**STATE OF NEW HAMPSHIRE**  
**BEFORE THE**  
**NEW HAMPSHIRE SITE EVALUATION COMMITTEE**  
**DOCKET NO. 2015-06**

**SUPPLEMENTAL PRE-FILED DIRECT TESTIMONY OF CARL MARTLAND**  
**ON BEHALF OF**  
**NORTH COUNTRY SCENIC BYWAYS COUNCIL**

**FILED IN OPPOSITION TO THE APPLICATION OF NORTHERN PASS**  
**TRANSMISSION, LLC AND PUBLIC SERVICE COMPANY OF NEW HAMPSHIRE**  
**D/B/A EVERSOURCE ENERGY**  
**FOR A CERTIFICATE OF SITE AND FACILITY TO CONSTRUCT A NEW HIGH**  
**VOLTAGE TRANSMISSION LINE AND RELATED FACILITIES IN NEW HAMPSHIRE**

**MARCH 24, 2017**

# Photo Simulation Presented to SEC by NP

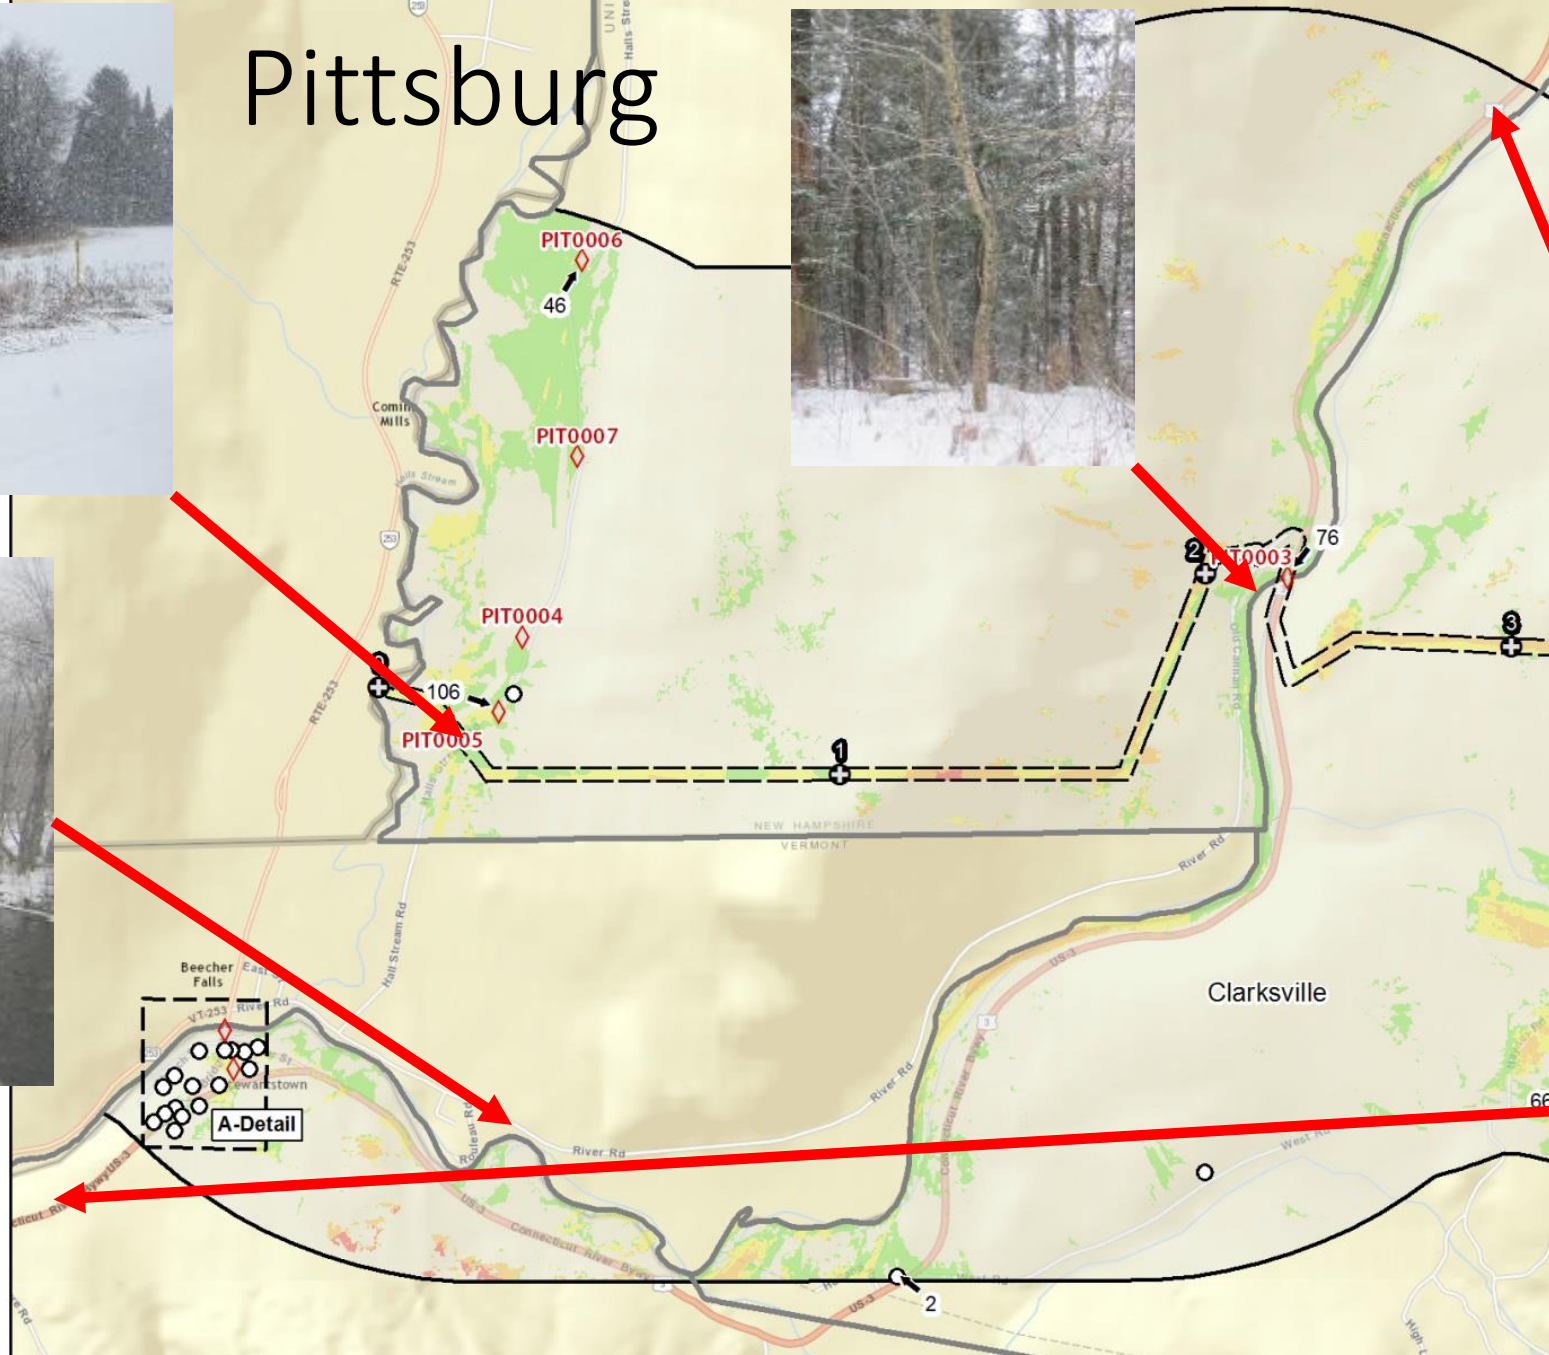
Using criteria from the US DOE's draft EIS, the proposed tower would have a "severe, unreasonably adverse" visual impact for anyone living near or traveling under the lines
